## Insufficient Heat

### —1974 Mustang w/Standard Heater

Figure 2 - Ash Receptacle Lid

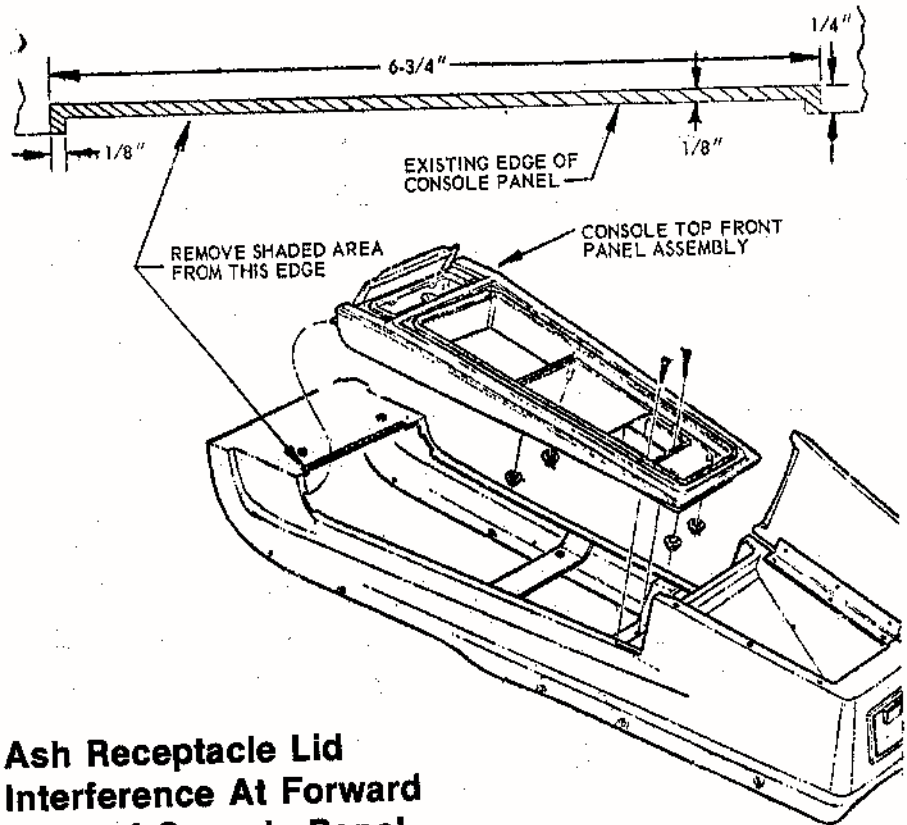
## Ash Receptacle Lid Interference At Forward Edge of Console Panel

When binding ash receptacle lids are encountered in vehicles built prior to the production correction, the swing clearance can be increased as described below:

2. Remove the console top front panel assembly to gain access to the front edge of the console panel as shown in Fig. 2.

3. Increase the size of the existing ash receptacle opening in the console panel by 1/8" as shown by the shaded area on Fig. 2.

Fig. 7 - Article 671

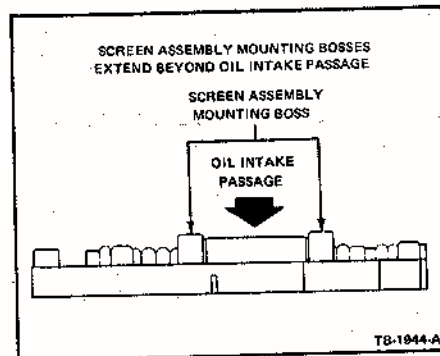
## Elimination Of Spacers Between Screen Assembly And Main Body Control

The main control body casting has been revised to eliminate the need for the three spacers between the screen assembly and main body control. When removing the main control, inspect the screen assembly mounting bosses and the part number cast in the control body.

If the part number cast into the control body is 74DT-7A101-BB (early design), the screen assembly mounting bosses are the same height as the oil intake passage. Spacers **must be used** between the screen assembly and the control body on these assemblies. If the part number cast into the control body is 74DT-7A101-BC (later design), the oil screen mounting bosses extend beyond the oil intake passage (See Fig. 7). Spacers **must not be used** on this assembly. If the three spacers are omitted between the screen assembly and control body on the early design, or if the three spacers are used with the revised design, the pump will cavitate resulting in low control pressure and transmission malfunction.

Fig. 54 - Article 722

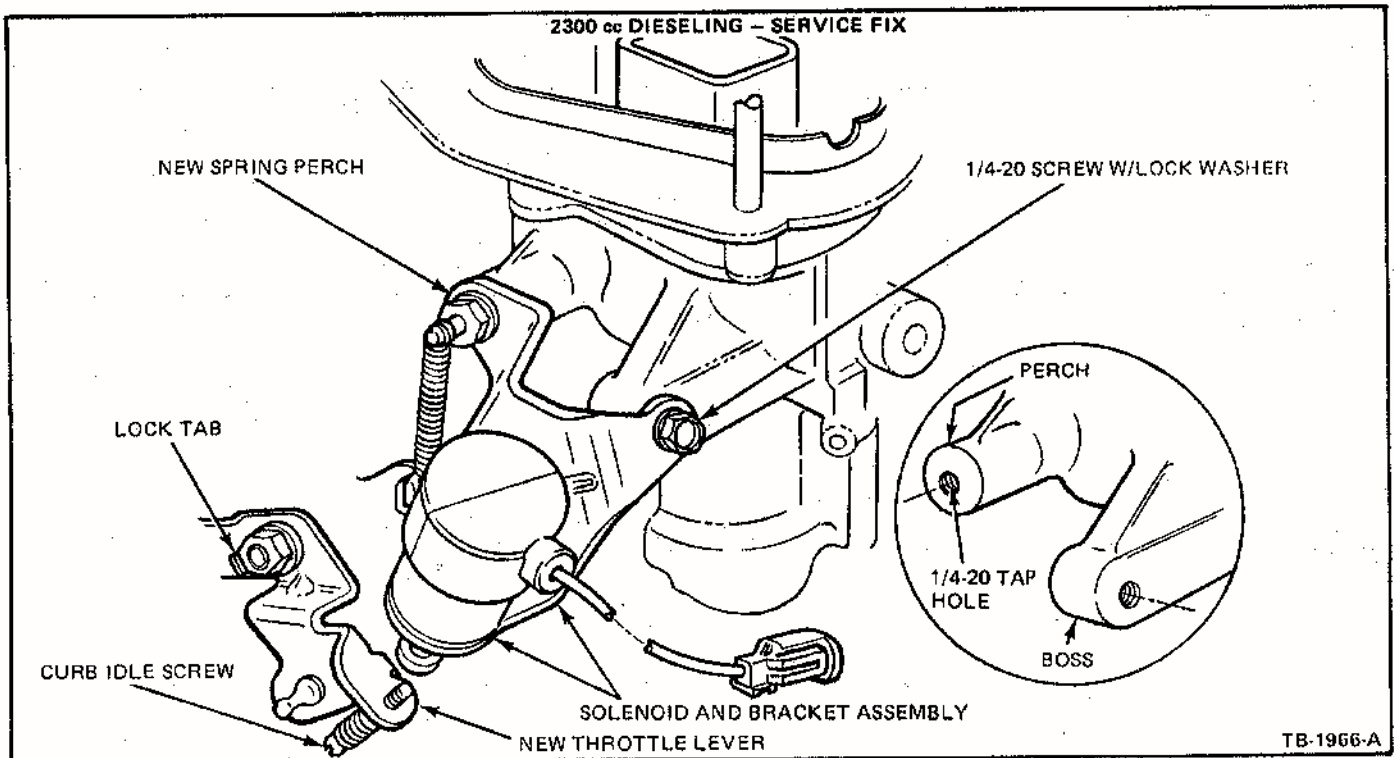
## Engine Dieseling And/Or Run-On After Ignition Key Is Turned Off

Engine dieseling can be corrected by installing a carburetor electrical throttle solenoid positioner kit (See Fig. 54) as follows:
